ASSESSMENT REPORT

1 Burroway Road, Wentworth Point SSD 6387 MOD 4

Figure 3: Proposed Site Plan

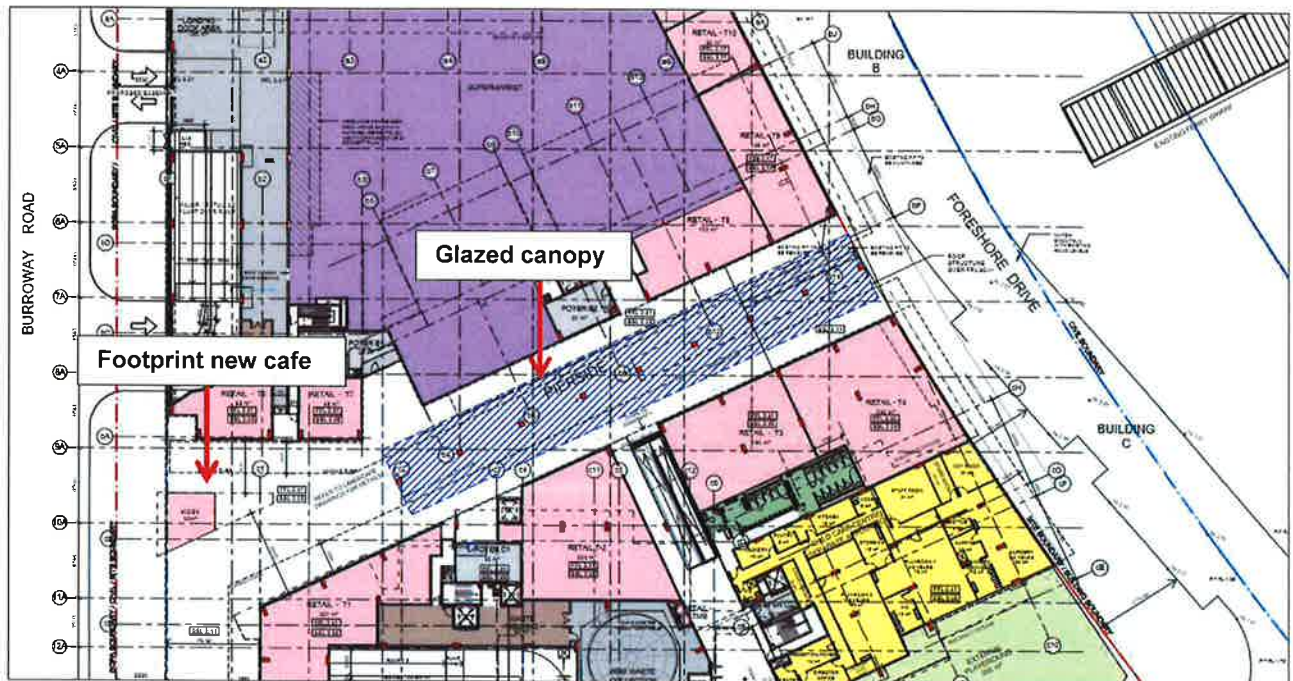
Council initially raised concern regarding the location of the café as it would impede the visual and pedestrian flows through the site. Following the amended scheme submitted with the RtS, Council raised no further objection to the location of the café, but recommended it be constructed of high quality materials. In relation to the canopy, Council recommended it be designed and constructed in accordance with the Building Code of Australia and designed to

SOPA raised no objection to the proposed canopy structure, but raised concern with the initial size and location of the cafe and the visual impact it would have on the through-site link. Following submission of the RtS, SOPA raised some issues relating to pedestrian movements within the area generally, and the need for a precinct wide pedestrian access strategy. The Department considers these issues are outside of the scope of the current modification request.

Issue	Consideration	Recommendation
<i>Public Domain Impacts (Cafe)</i>	<ul style="list-style-type: none"> • The proposal seeks approval for a new café at the entrance of an open air at-grade through-site link which provides public access between Burroway and Foreshore Roads to the ferry terminal. • SOPA and Council initially raised concern with the location and size of the cafe and the potential loss of visual connection to the foreshore and ferry terminal from Burroway Road. • In response, the applicant relocated the café to the west and reduced its size from 50 sqm to 30 sqm so a 10 metre wide through site link would be retained. • Council acknowledged the improvements of the revised proposal and considered it would minimise impacts on the public domain. • The Department considers the location and size of the proposed cafe (as amended) is appropriate given it would: <ul style="list-style-type: none"> – activate the entrance to the site on Burroway Road; and – maintain a 10 metre wide through-site link consistent with the requirements in <i>Wentworth Point Precinct Masterplan 2030</i>; – continue to allow direct pedestrian access to the ferry terminal and bus interchange; and – retain adequate visual permeability through the site. • The Department is also satisfied the café is appropriately designed to complement the architecture and design of the surrounding buildings and public domain. • The Department is therefore satisfied there would be no adverse impacts on the public domain. 	No additional conditions or amendments necessary.

<i>Canopy Design</i>	<ul style="list-style-type: none"> • Council and SOPA are supportive of the proposed canopy. Council recommended the canopy be designed and constructed in accordance with the Building Code of Australia and the plaza maintains appropriate access for people with disabilities. SOPA recommended it be designed to manage stormwater runoff. • The proposed canopy contains intermittent solid sections to provide sunshade and all-weather protection for pedestrians. The design allows for the penetration of light and free movement of air as it spans above the retail awnings below. It would be supported by a single row of columns to minimise impacts on pedestrians and disabled access through the link. • The applicant confirmed rainwater would run off the canopy to adjacent awnings which have sufficient capacity to convey rainwater. • The Department considers the canopy would make a positive contribution to pedestrian amenity. • The Department is satisfied the design would not have an adverse impact on the visual amenity of the site, stormwater management, or disabled access. 	No additional conditions or amendments necessary.
